**AGENDA**  
**PLAN COMMISSION**  
**Tuesday, June 9, 2020 at 6:30 p.m.**

**SUBJECT:** Review of Applications for a Rezoning and Site Plan for a new 12-unit apartment building at 965 S. Pine Street

**To:** Kristine Anderson, Plan Commission **Date:** May 28, 2020  
**From:** Greg Governatori  
**CC:** Carina Walters, Megan Watkins, Gregory Guidry, Peter Riggs, Tanya Fonseca,  
**Subject:** Spring Brook Drive – Proposed 12-Unit Building

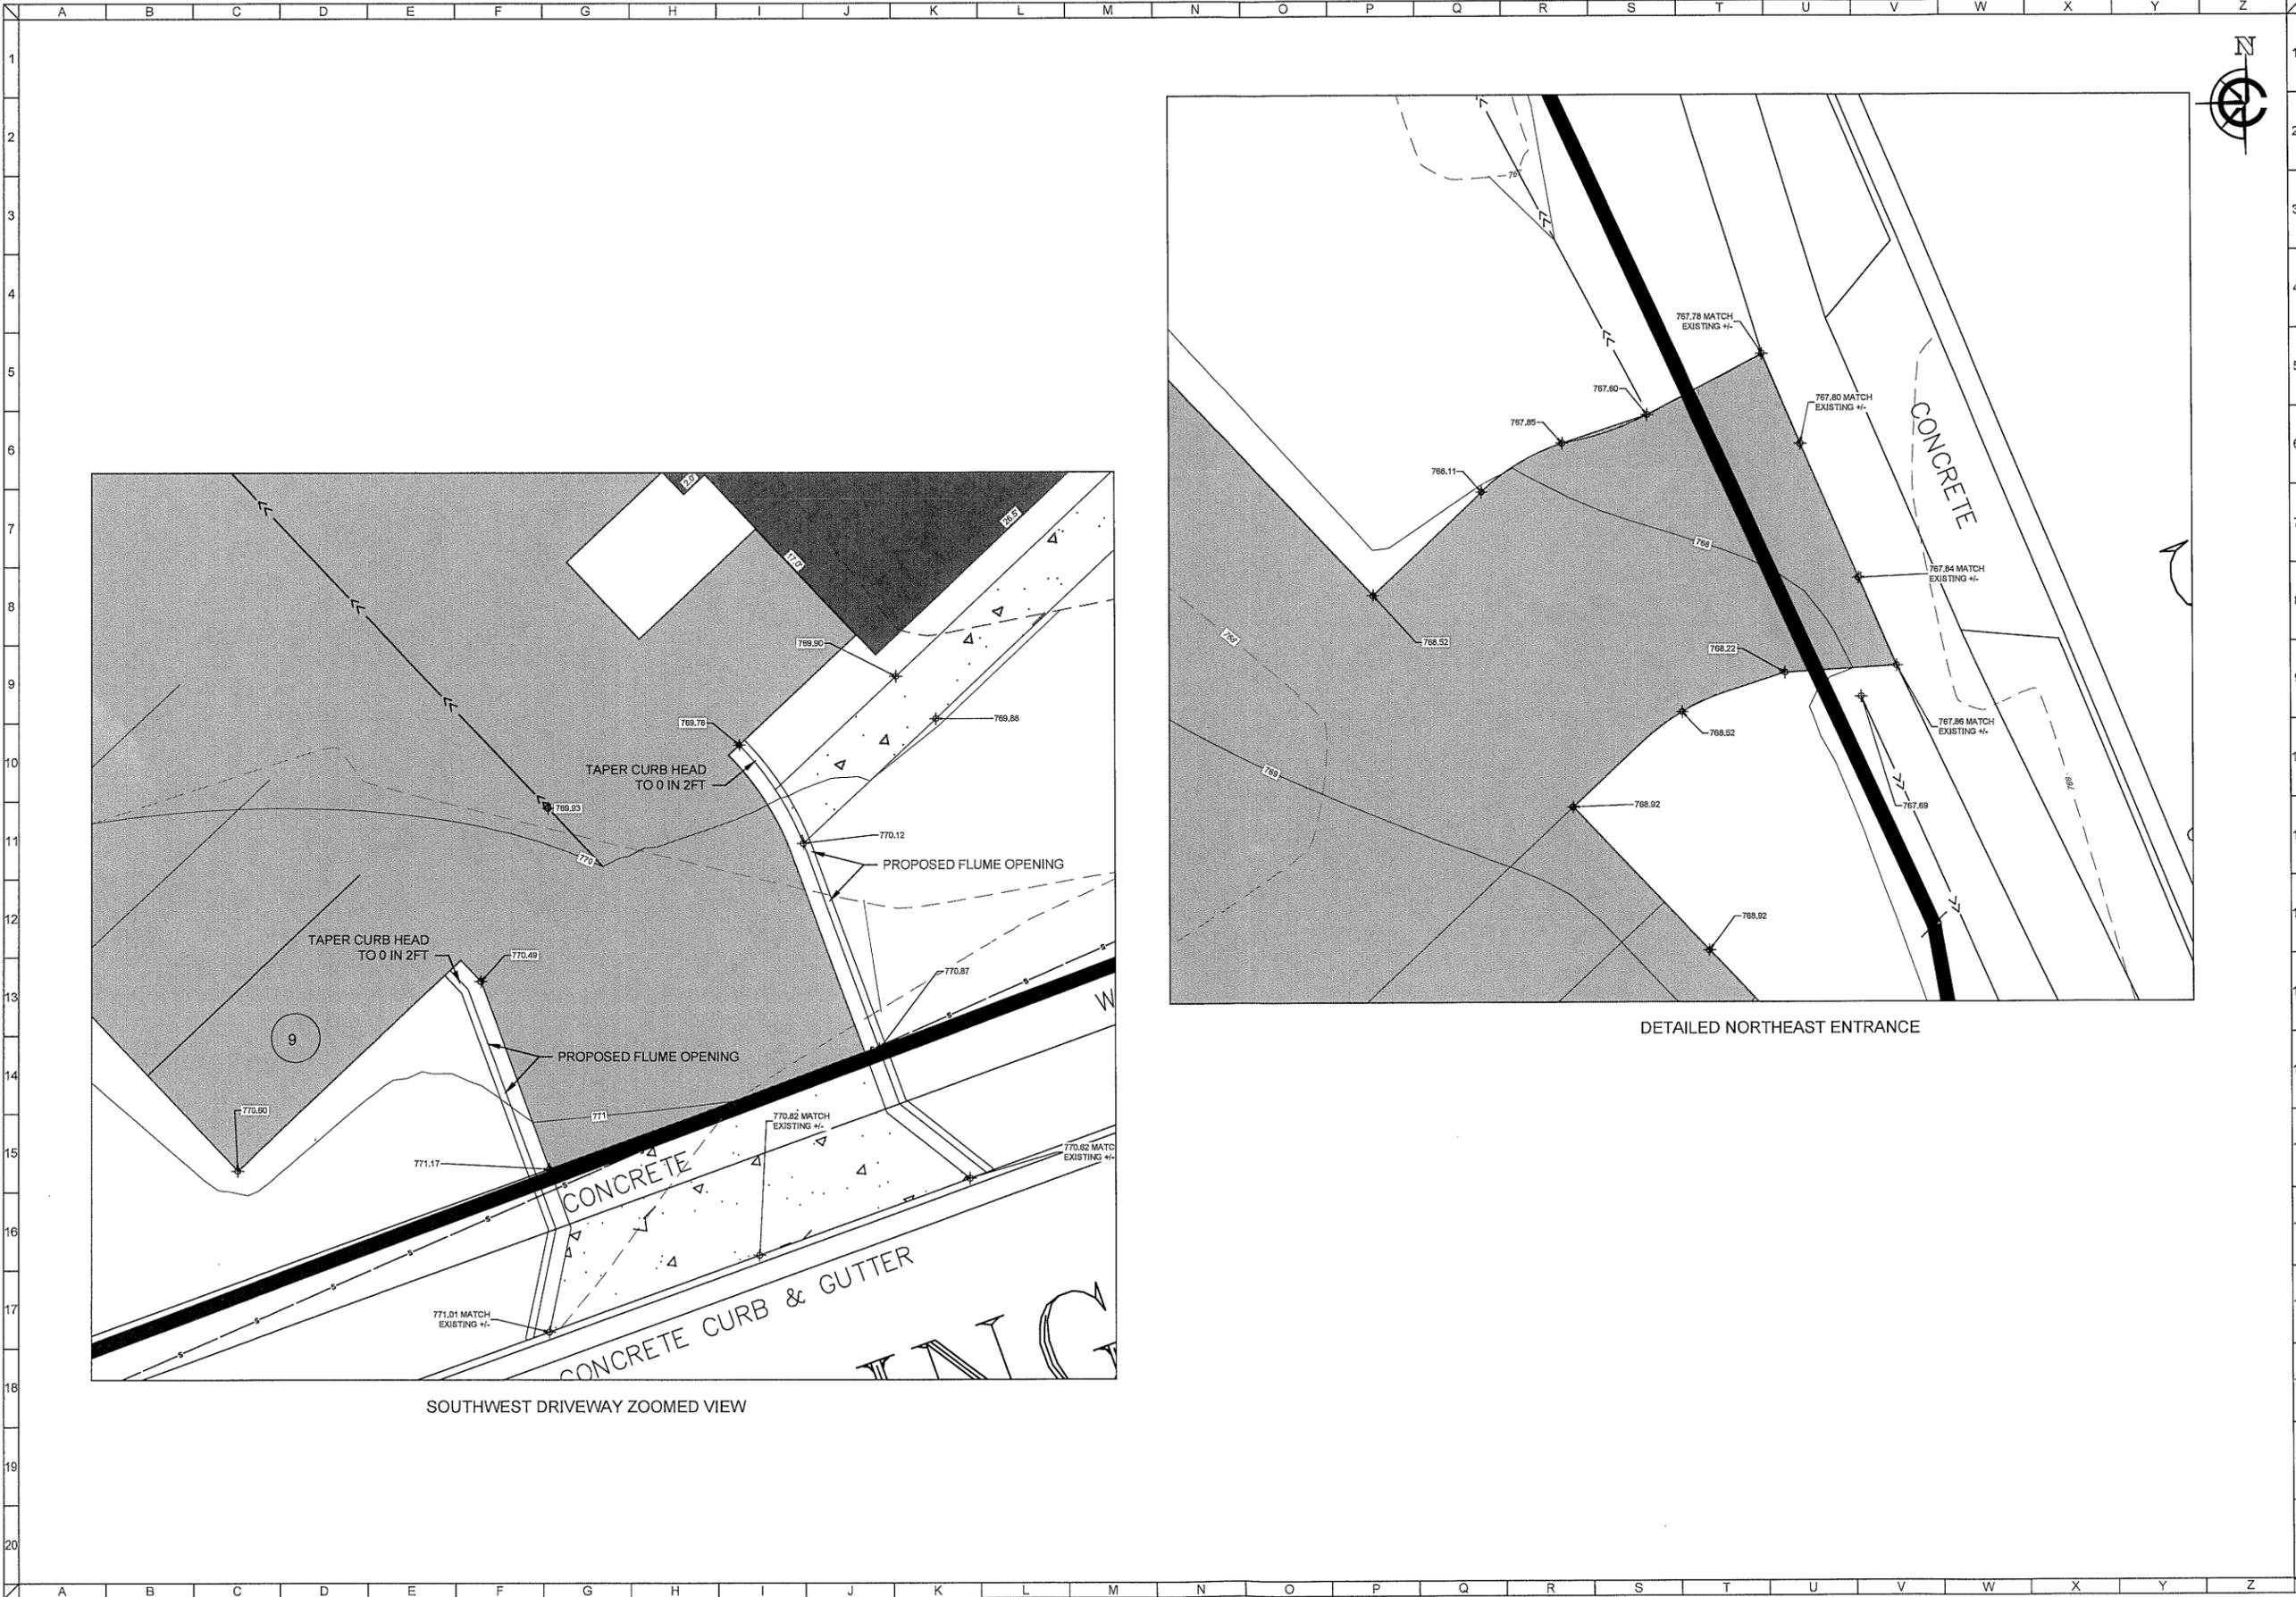
1. Spring Brook Creek shall be labeled.
2. The sanitary lateral is shown as requiring the removal of a significant amount of sidewalk. The lateral should be modified to cross the existing sidewalk as close to perpendicular as possible. Or the sidewalk replacement shall be included in the civil plans.

6. The Watermain lateral has a label at the end "Fire Department connection" if this is correct, please provide additional detail in regards to the connection requirements, as well as the water service to the building.

7. The silt fence is shown incorrectly and must fully encompass the demolition, utility work and all site grading activities.
8. The restoration plan shall consider the appropriate seed mixes for work done within the shoreland area where the existing structures, garage, shed, etc are being removed

10. There are two proposed flumes at the driveway from Spring Brook Drive but no detail in regard to grades or purpose.
11. There are existing trees on the property it is assumed that based on the provided landscape plan that all existing trees will be removed. The trees were not shown on the site survey or the civil plans. In addition, and specifically areas along Spring Brook Creek (within 75') shall be clearly defined if removal of vegetation is proposed.

12. The site landscaping plan shows activities and plantings outside of the planned erosion control limits. The erosion control must encompass all work completed as part of the project including landscaping. Please coordinate with the Landscape architect and ensure proper erosion control is shown.

13. There are details for curb stops and ADA accessible signage, however reference on the site plans sheets for location and applicability were noted.

We recommend approval of the submitted site plan, subject to applicant providing final engineering drawings for construction addressing the items as outlined above.
